## COMMITTEE REPORT

BY THE DIRECTOR OF ECONOMIC GROWTH AND NEIGHBOURHOOD SERVICES  
READING BOROUGH COUNCIL  
PLANNING APPLICATIONS COMMITTEE: 13 January 2021

**Application Nos.:** 192032/HYB, 200822/NMA, 200823/NMA, 190441, 190442

**Address:** Station Hill, Reading

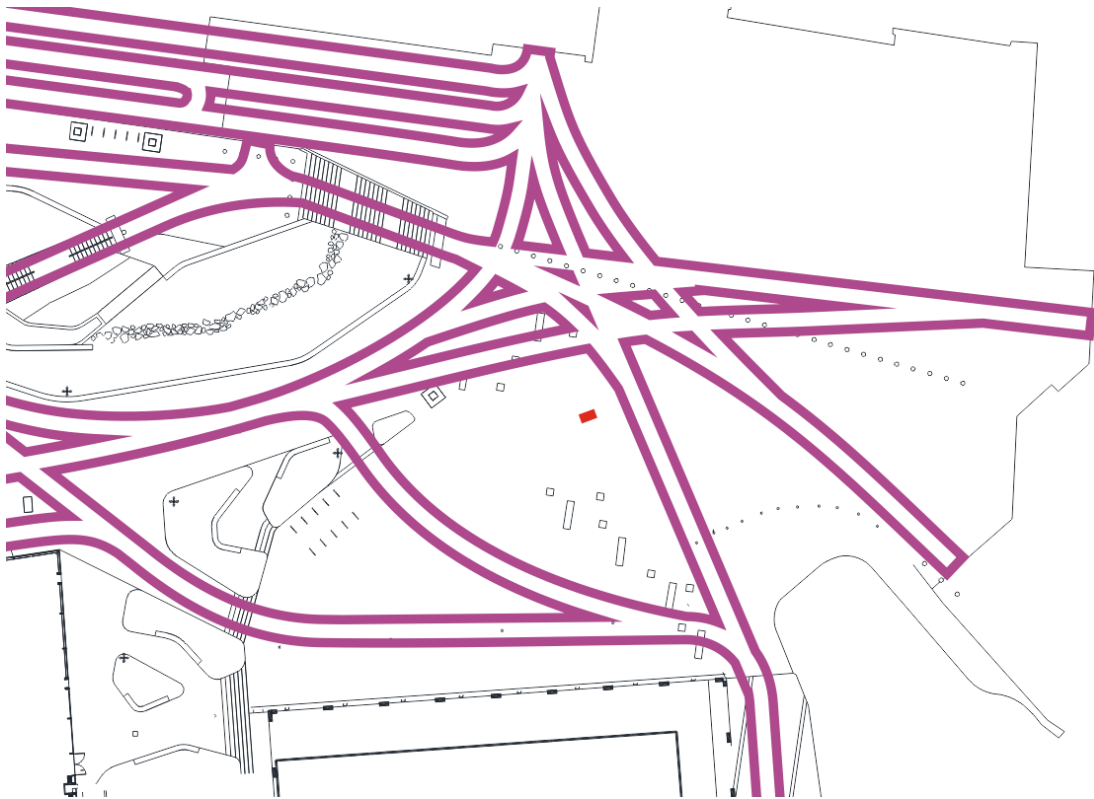
*I note that the landscape scheme included within the micro simulation model has been slightly revised and I accept that the latest design is an improvement over what was previously modelled as it provides greater space for pedestrian movement.*

*The modelled forecast matrix for the micro simulation is based on the period between 17:00 and 18:00, since through analysis undertaken from reviewing taxi and passenger demand, this was identified to be the busiest period of the day. The forecast flows account for a doubling of observed station passengers, pedestrians walking through the Station Interchange / Station Square and the additional Station Hill people movements.*

*It should be noted that the model has been updated to reflect the reduced step width and the removal of the station entrance planter area. These have not been updated in the 3D backdrop image, but are in the underlying modelling, hence pedestrians will appear to be walking through the planter area. This was the rationale for the removal of this planter area.*

Figure 6.7: Proposed Taxi Rank Capacity (22 Vehicles)

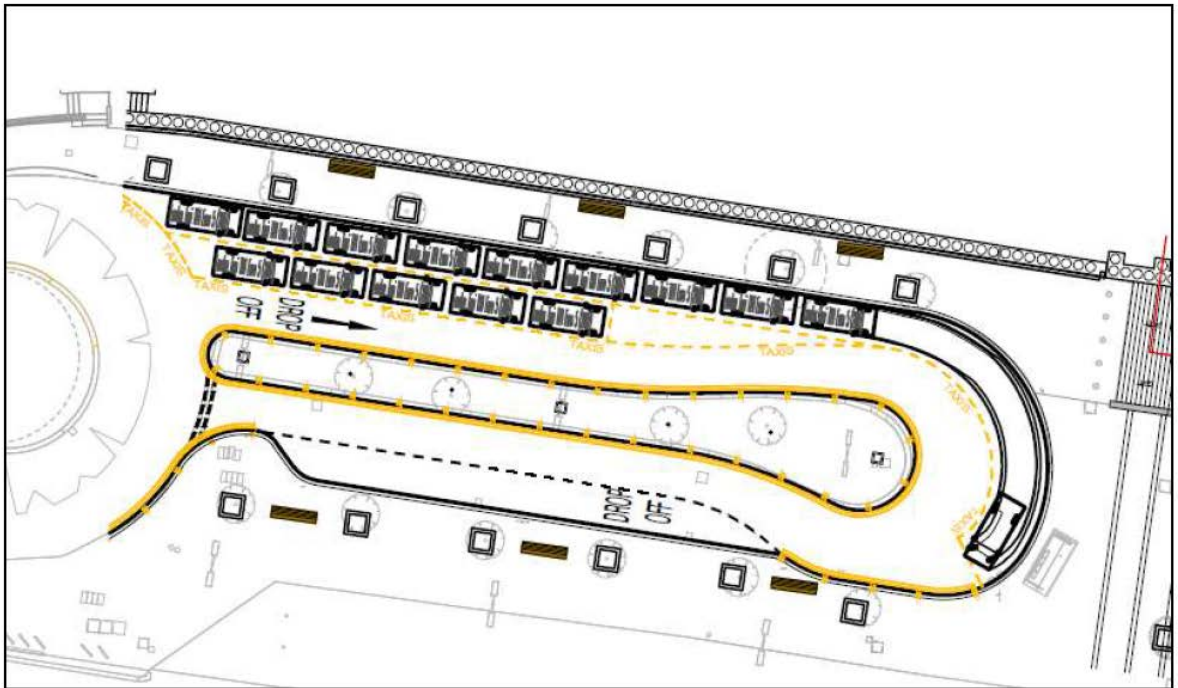
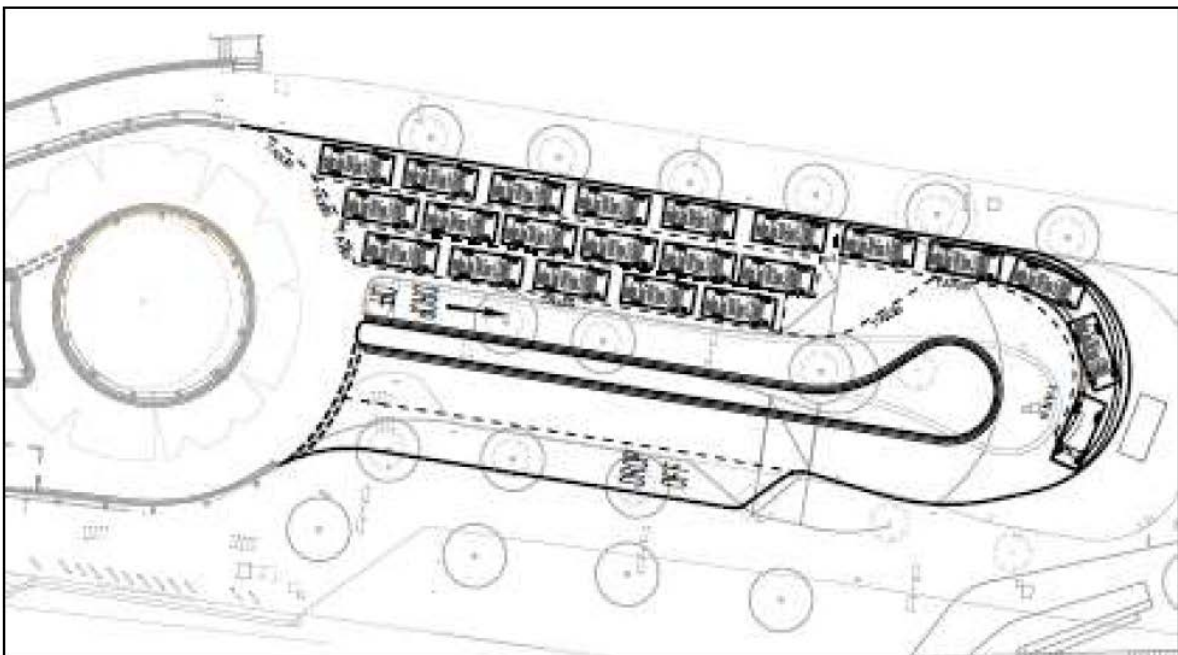
*The proposed Pocket Park extends into the south west interchange area and therefore alterations are required to the south west interchange. Extracts of the existing and proposed layouts can be found below (Figure 6.6 and Figure 6.7 of the Transport Assessment), these illustrate that an increase of 4 taxis has been accommodated by widening the area available for queueing.*

*Given that the proposal increases capacity I am happy that this is acceptable.*

*The proposed alterations to the area north of the site including the pocket park and the taxi rank area will be subject to agreement with RBC Highway Authority by means of a s278 agreement.*

Figure 5.1 Phase 2, 3 & Thames Tower Combined Service & Delivery Profile Accumulation

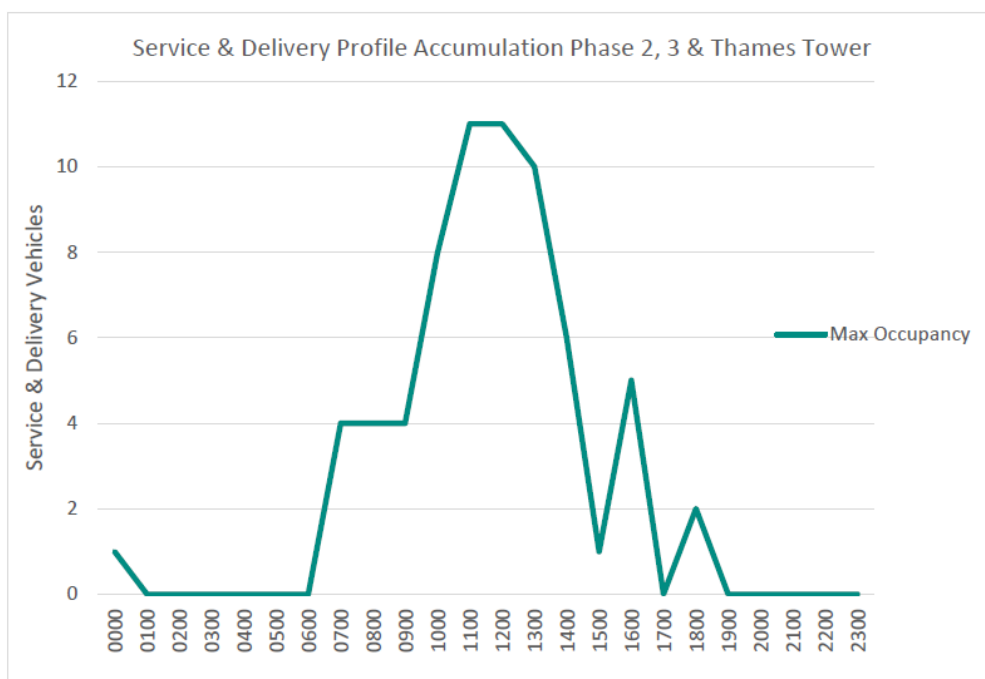
The existing Thames Tower delivery profile has been factored to create a delivery profile for the Station Hill Northern Scheme. The delivery profile has been derived from categorising entry and exits into hourly segments, whilst an estimated maximum occupancy within an hour has been included into the calculation through the average estimated dwell time of 25 minutes per vehicle. This has been calculated from the Thames Tower survey, which admittedly includes vehicles parked/dwelling for significant periods that increases the average dwell time. As such, the calculated number of delivery and service vehicle utilising the service bays at a given time within an hour is estimated by factoring down the number of arrivals by the average dwell time. This has been presented below within Figure 5.1.

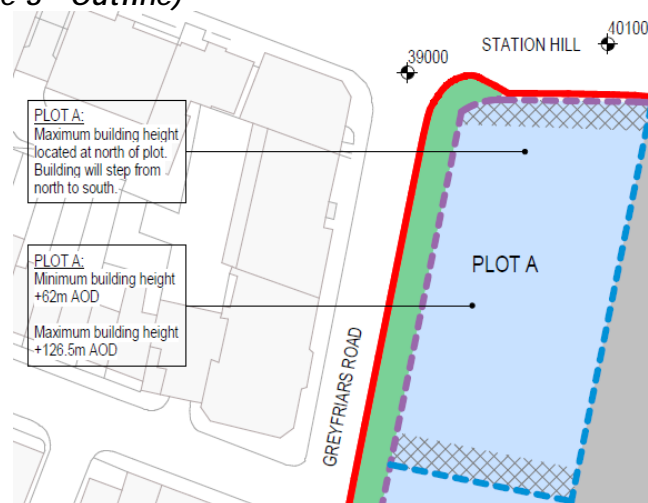
6.33 Plot G would rise to 123 metres AOD in height before stepping down to 16 storeys (110.2m AOD) for a short section at a point approximately 14 metres from the south façade and then dropping again to 9 storeys (81.9m AOD) at a point approximately 7 metres from its southern facade. It would measure approximately 50m north-south and 40 metres east-west. It would rise above Thames Tower which sits immediately to the east at 103.3 metres AOD and have a larger footprint. The building would be slightly taller than the hotel recently approved at 29-35 Station Road (permission 181930) but with a much larger footprint.

6.34 The proposal would be a substantial building within this setting, however it is relevant to note that the extant permission (SH3) also provides for a pair of large buildings with quite a different arrangement. Proposed Plot G would extend across

Extract from drawing A-705-P03

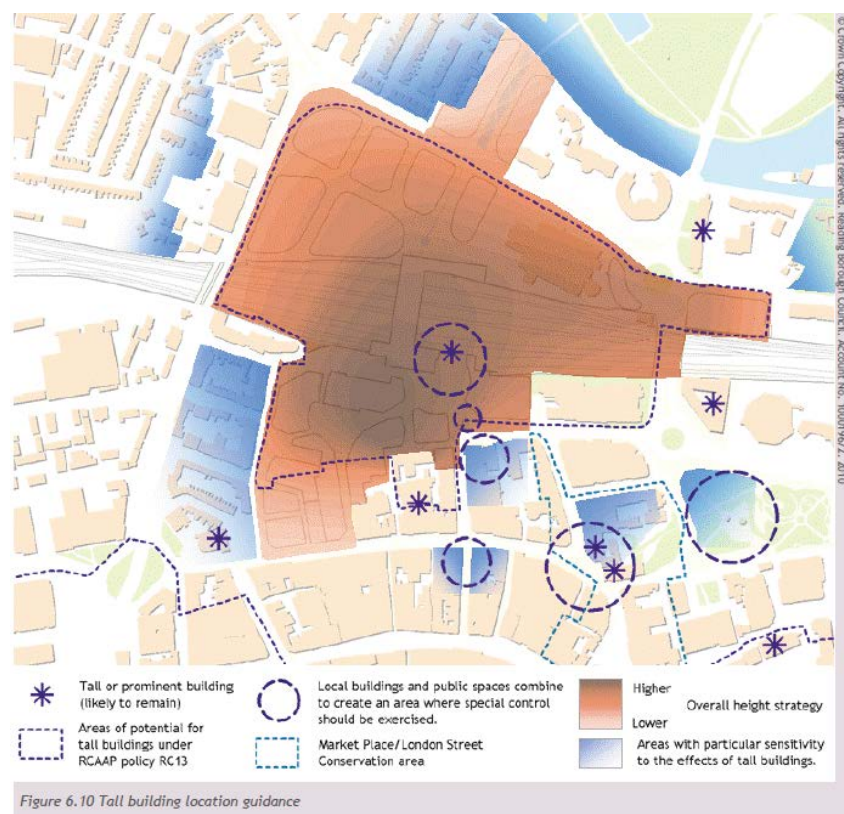
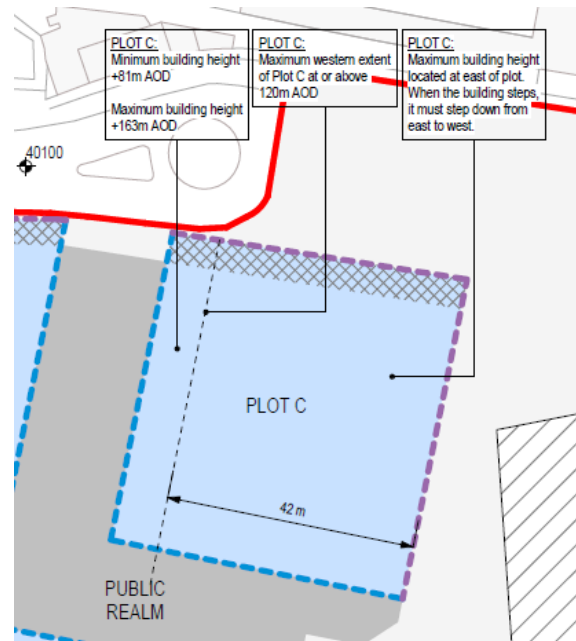
- 6.48 The tallest building has shifted slightly westwards under the current proposals compared with the extant permission. Policy CR10a requires tall buildings to follow a pattern of the tallest buildings at the centre of the tall building cluster, close to the station, and step down in height from that point towards the lower buildings at the fringes. This is echoed in the RSAF which requires tall buildings to rise up around the Station 'nexus' and the area of maximum permissible height within the 'dome' of the 'crown' immediately adjoining and to the south of the station entrance. The effect of the building massing should be 'dramatic' (RSAF paras 6.11 to 6.14). The tallest buildings of SH2 and SH3 are both closest to the station entrance. The current proposals deviate slightly in this regard with Plot G closest to the station entrance but not as tall as Plot C. It is considered that, although different from previous versions, this is supported by Figure 6.10 of the RSAF (copied below) which shows the 'hotspot' for the tallest buildings to the north and west of Thames Tower and supports the greatest height being focussed broadly where it is currently proposed - at the eastern edge of Plot C.

- 6.49 The revised parameter plans confirm that the building on Plot C must step down from east to west. This is clarified further in the revised Design Code (para 4.8.4) which states that the tallest part of any buildings on Plot C must be to the east of the plot and further revisions which show a fixed vertical boundary line which sets where the maximum extent of the building would be to ensure a step is built into the design of a wider footprint building (see below).
